**SHEARON HARRIS NUCLEAR POWER PLANT, UNITS 2 AND 3
DOCKET NOS. 52-022 AND 52-023
SUPPLEMENT 2 TO RESPONSE TO REQUEST FOR ADDITIONAL INFORMATION
REGARDING THE ENVIRONMENTAL REVIEW**

**Shearon Harris Nuclear Power Plant Units 2 and 3
Supplement 2 to Response to NRC Request for Additional Information Regarding the
Environmental Review, dated November 13, 2008**

NRC RAI #: 4.3.1-2

NRC RAI #: 9.4-1

Locations near the Plant
 Attachment 4.3.1-2A,
 Figure 4

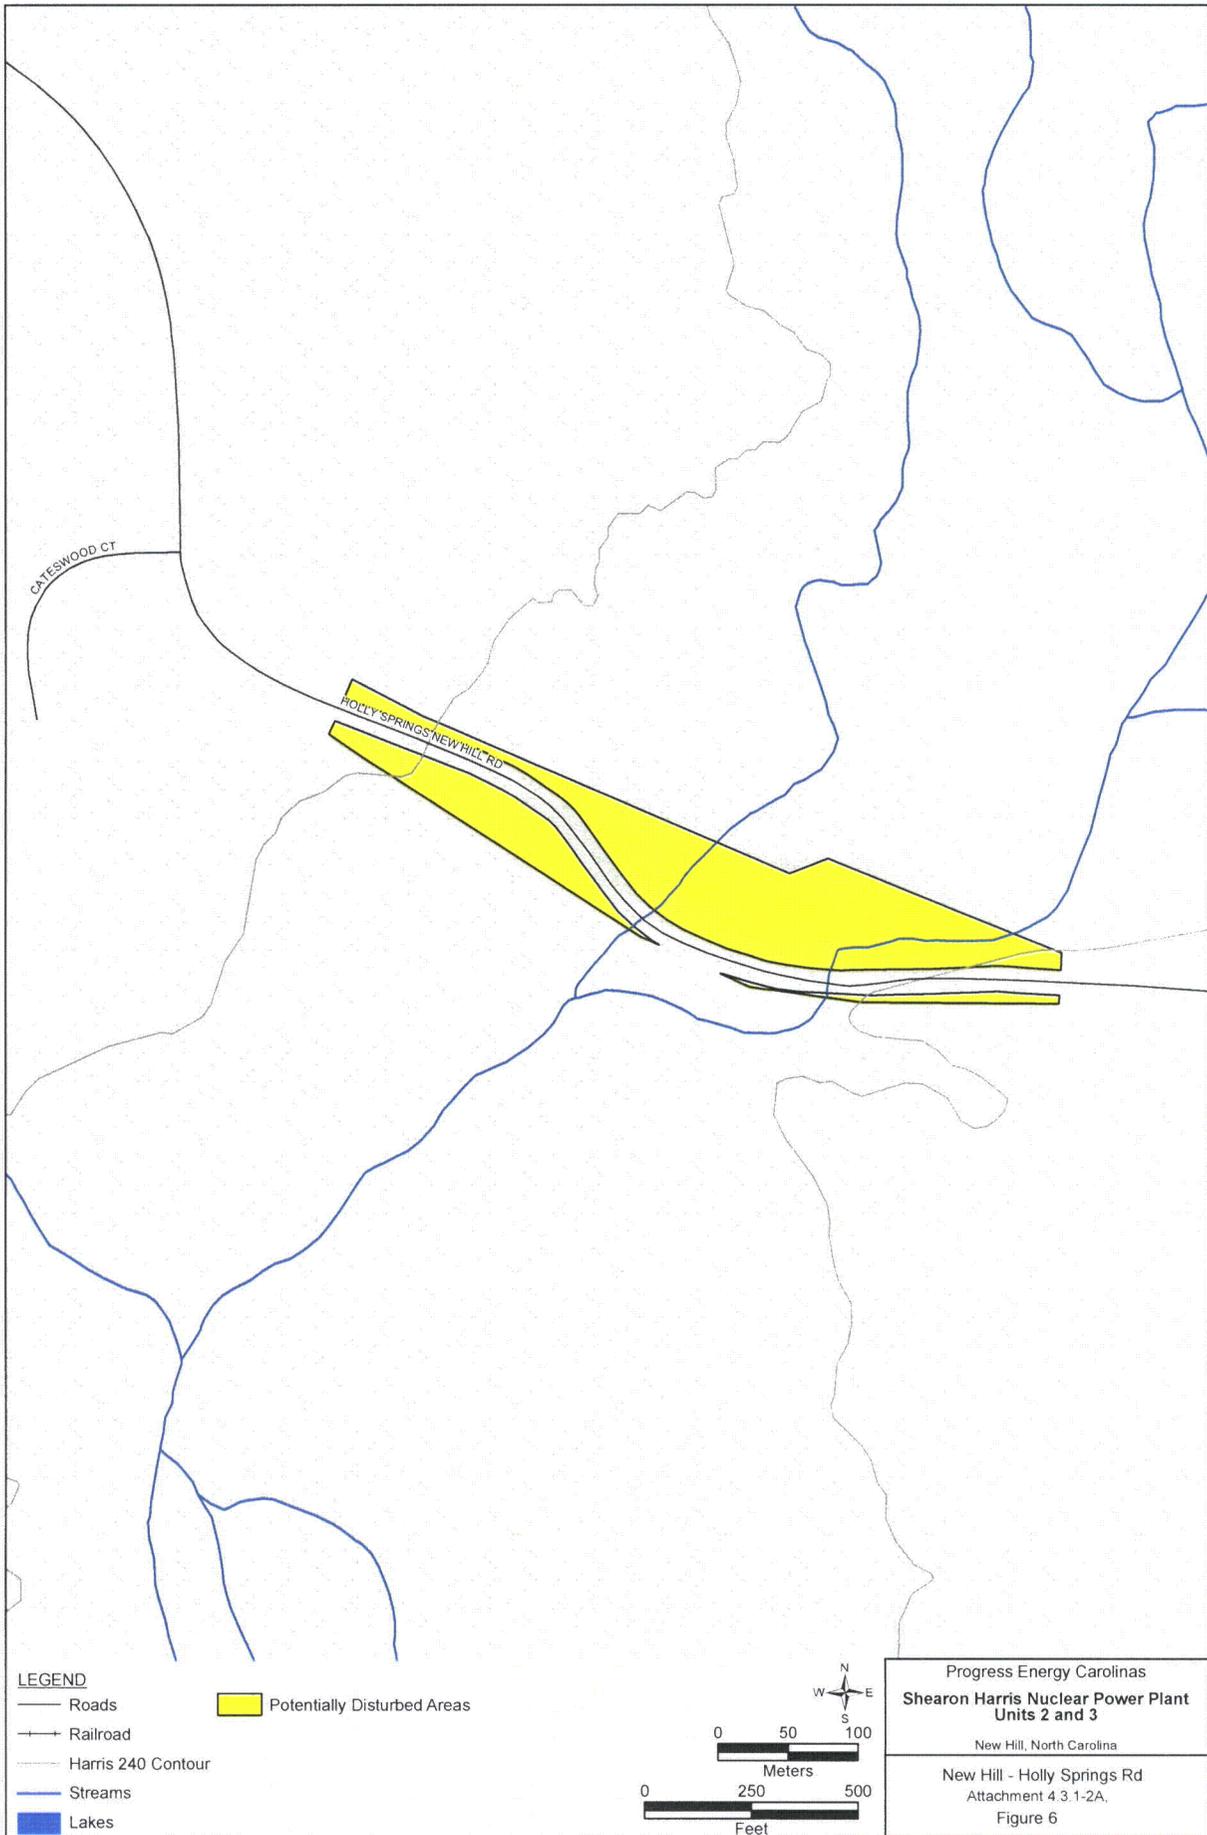
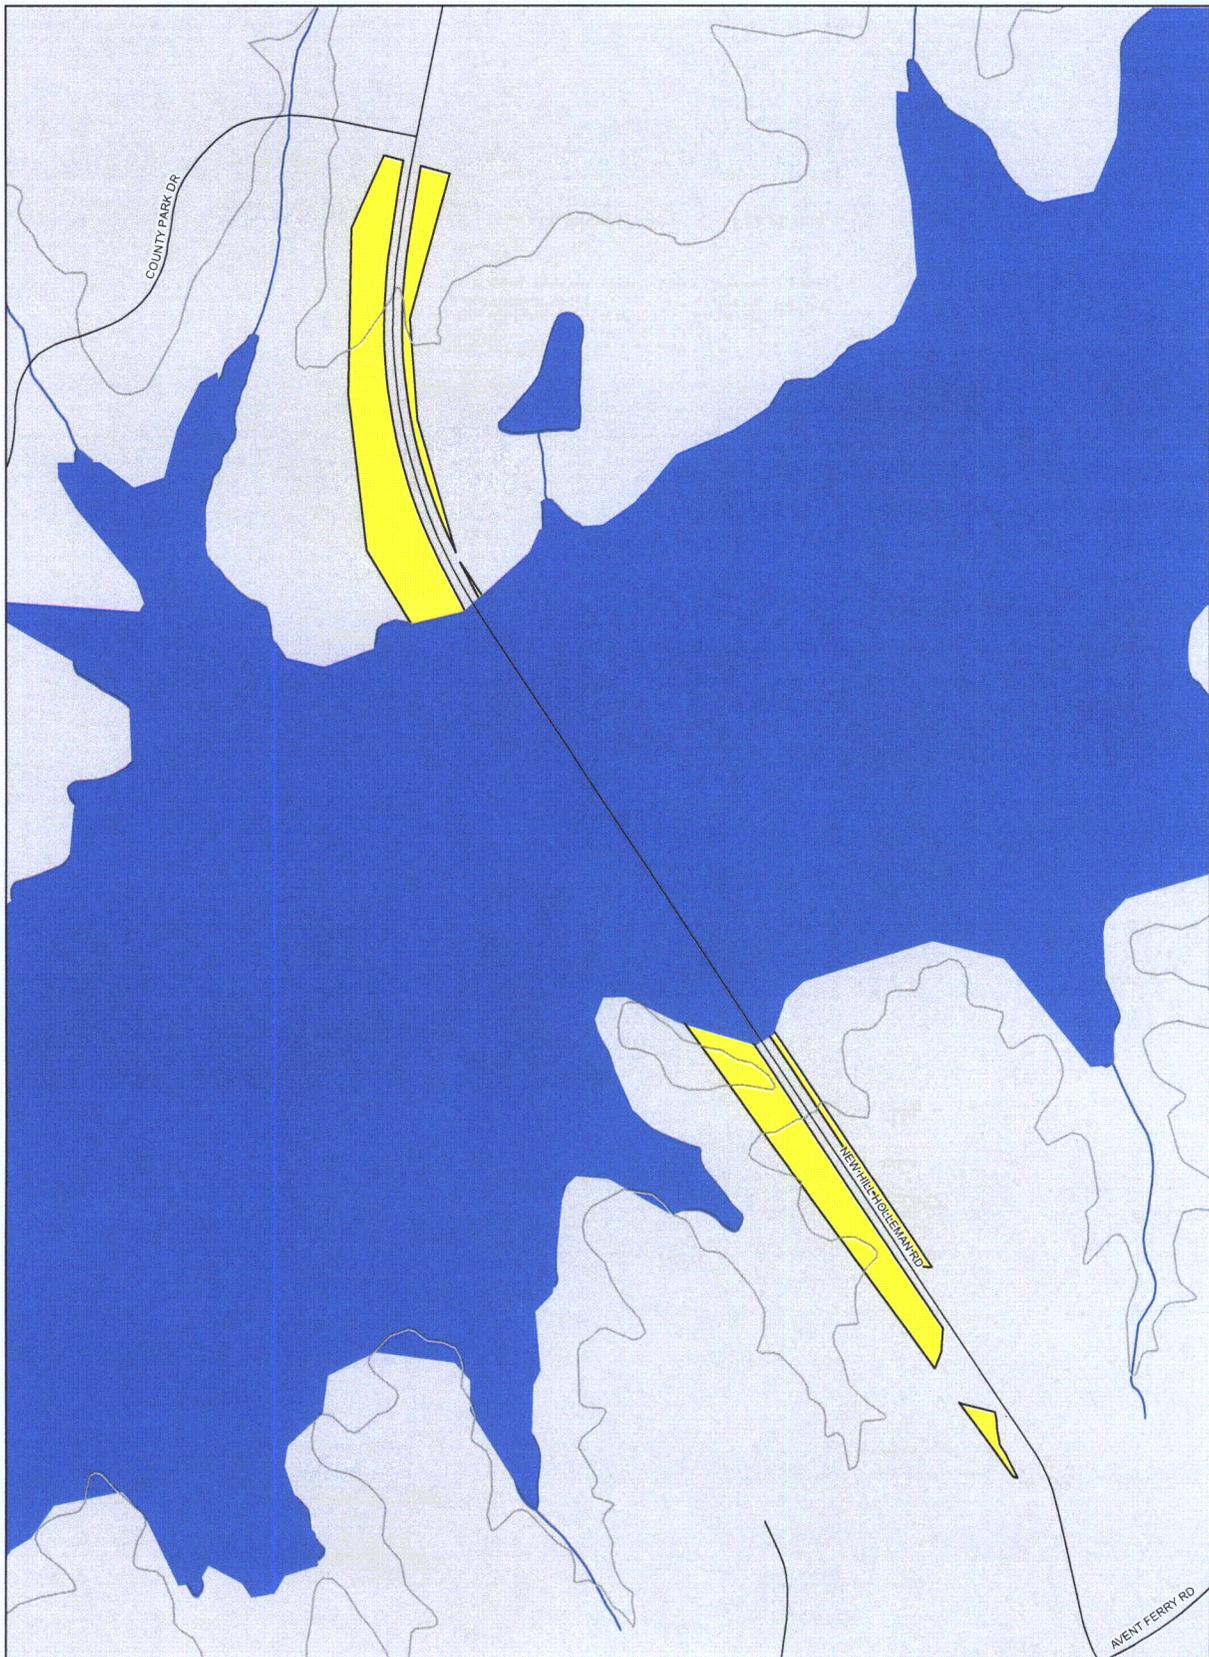
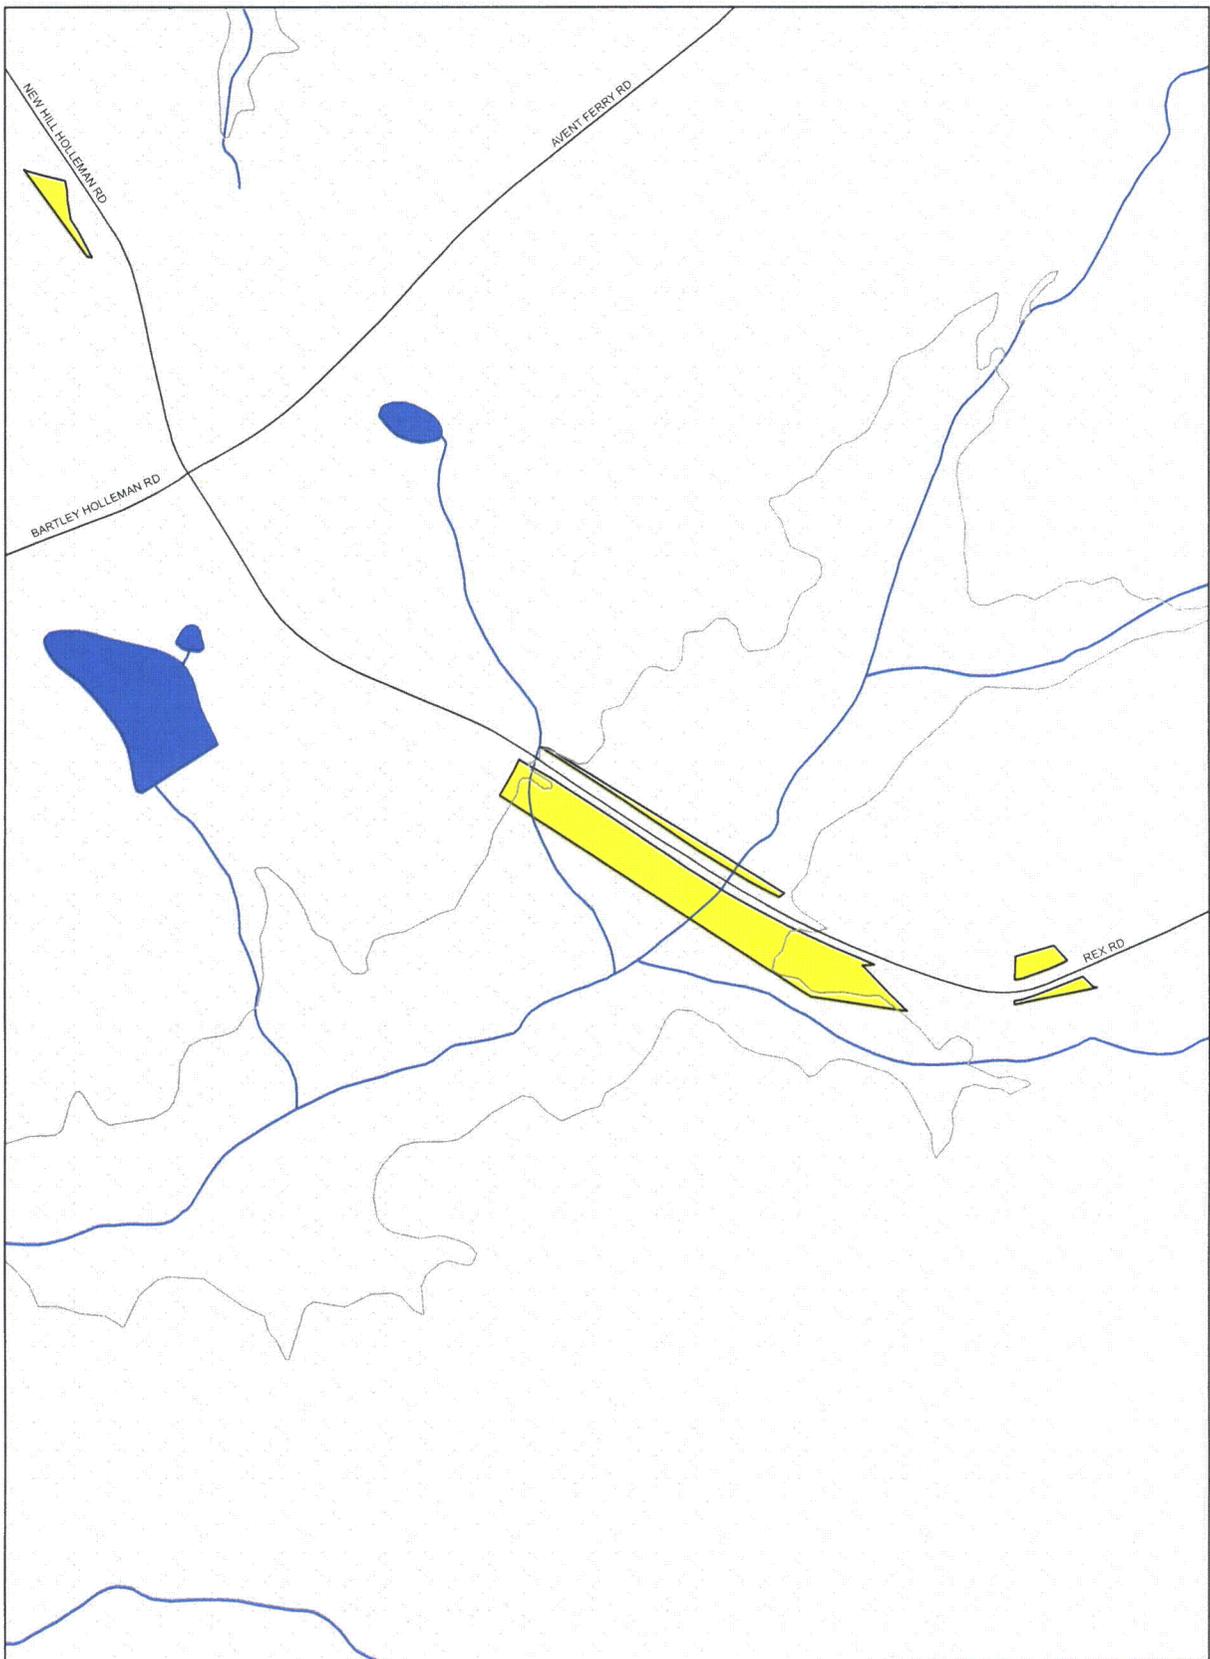
Confirm the locations of various proposed construction project areas and activities and provide information from the most recent terrestrial and wetland surveys of areas that will be impacted during construction.

Also provide RFI-158 CH2M Hill or most current plan and design – for depiction of temporary construction areas.

Discussions held at the site audit indicated that there may be changes to the proposed locations of various construction activities and construction materials sites and/or that some construction and roadway improvement areas have not been surveyed to characterize the resources. Please provide information and figures describing the proposed locations of temporary construction and laydown areas. Provide recent survey data for wetlands and terrestrial habitats, including wildlife and plants that may be impacted by both temporary and permanent construction not addressed in the ER, including but not limited to: temporary laydown areas for unit 3, construction parking areas, cooling tower locations for units 2 and 3, Wastewater Treatment Plant (WWTP) and any expanded WWTP lines, and any roadway improvement or construction projects outside the 220 to 240 contour around the reservoir. Provide the number of acres to be affected and the dominant habitat types for each area.

Potentially disturbed areas related to temporary and permanent construction, including temporary laydown areas for HAR 3, construction parking areas, cooling tower locations for HAR 2 and HAR 3, wastewater treatment plant (WWTP), any expanded WWTP lines, and any roadway improvement or construction projects outside the 220-ft. to 240-ft. contour around the reservoir, are shown in Attachment 4.3.1-2A. This set of figures was developed based on the information included in RFI-158, as well as available subsequent information regarding construction plans.

Progress Energy Carolinas
**Shearon Harris Nuclear Plant
 Units 2 and 3**
 New Hill, North Carolina
 Progress Energy Carolinas Exclusionary Areas
 Attachment 9.4-1A, Figure 1

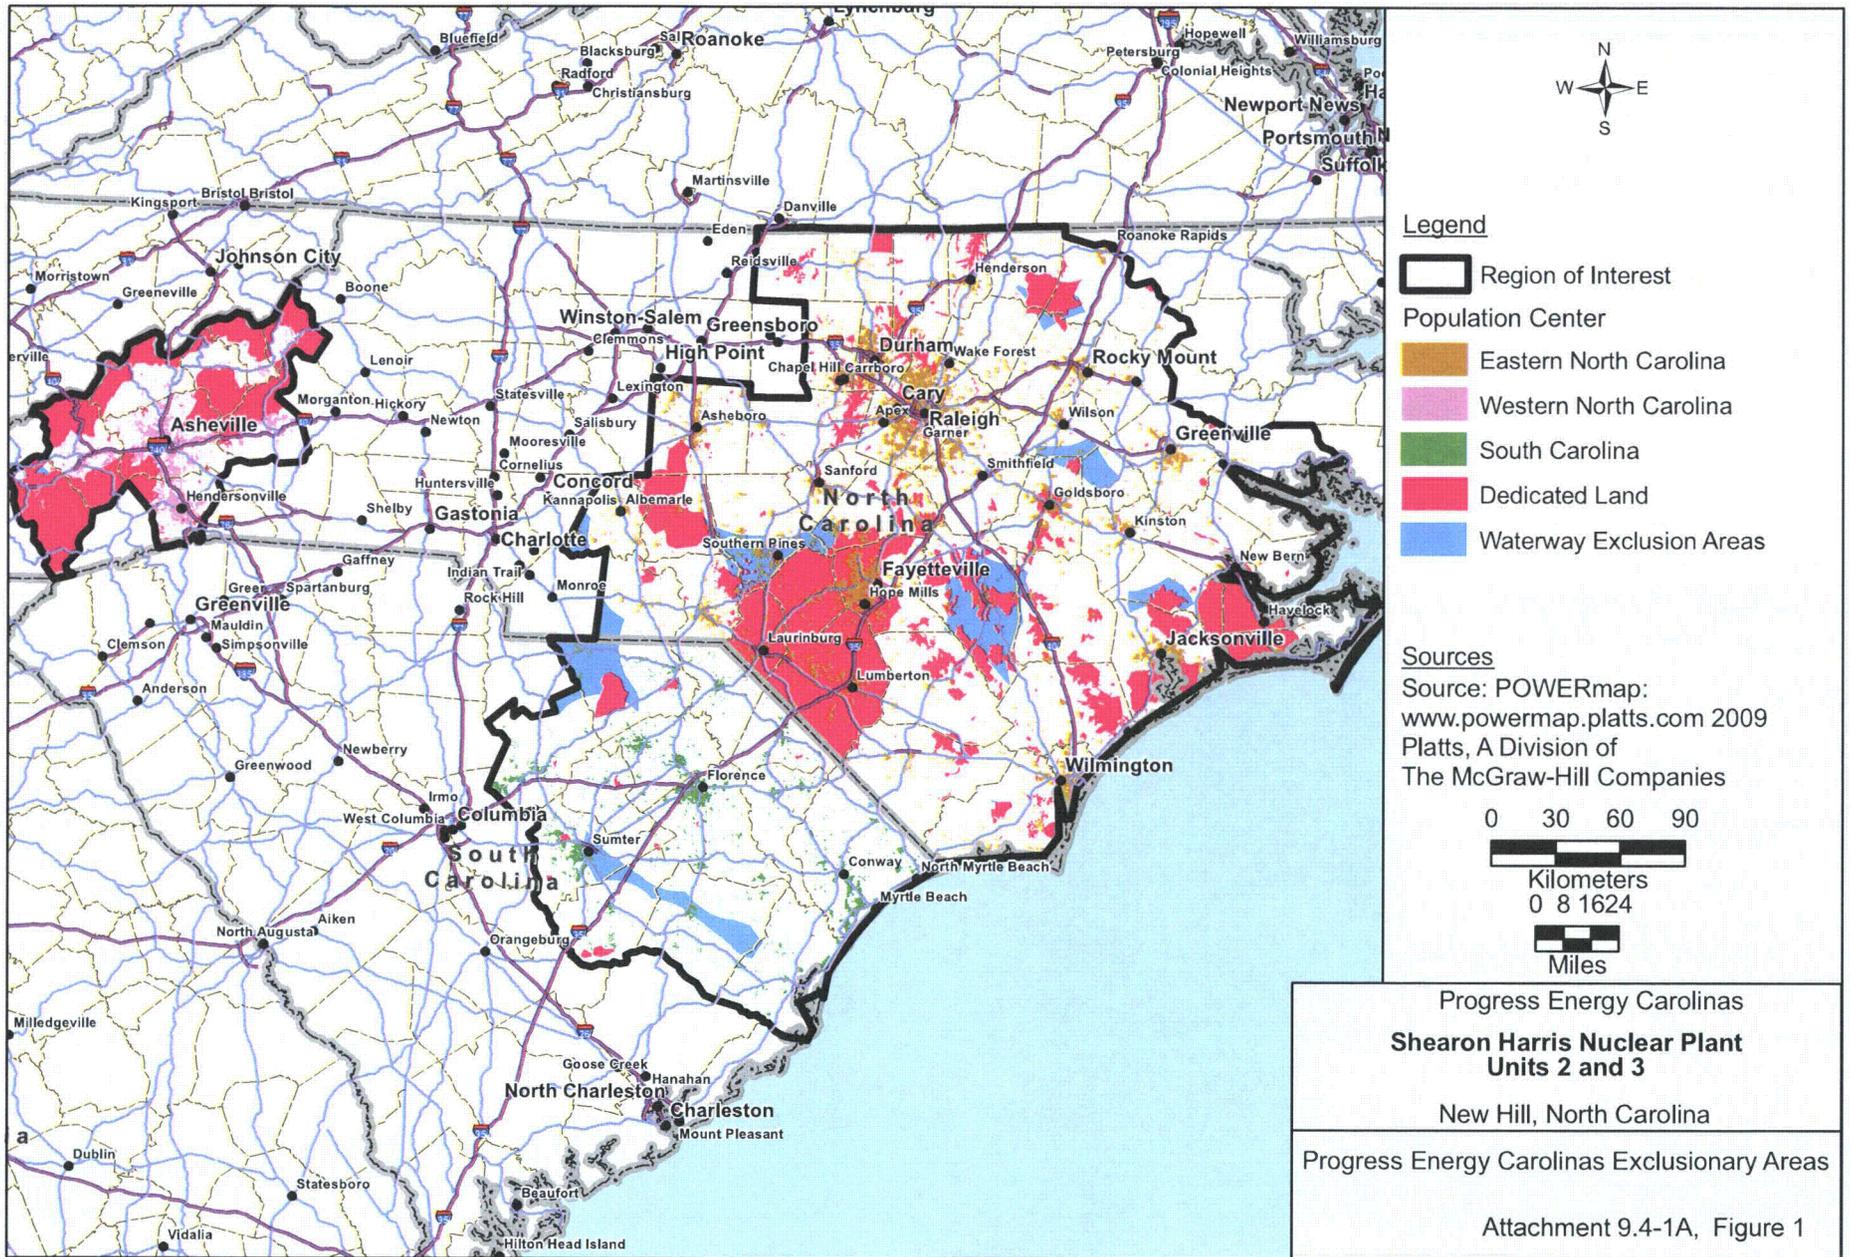
Provide supporting data and information demonstrating a quantifiable alternative site selection process in the revised ER that can be cited in the NRC EIS for the proposed construction and operation of Harris Units 2 and 3.

The alternative site selection process should follow a clear and defensible process to determine the final alternative sites, and the proposed site. Analysis performed on the four alternative sites to determine the proposed Harris site is clear and logical; however it is not clear how the region of interest was screened to provide candidate areas, potential sites, and candidate or alternative sites. Please provide a clear analysis of the site screening process from the defined region of interest to the selection of the four alternative sites.

Figure 1 identifies the criteria used to screen the ROI (some of the identified excluded areas overlap).

Screening information was obtained from publically accessible geographic information system (GIS) database websites.. Information gathered from the initial screening was used to identify areas not affected by the exclusionary screening criteria. The GIS information was layered to produce a figure that represented the suitable candidate areas for the potential placement of a nuclear power facility (see Figure 2).
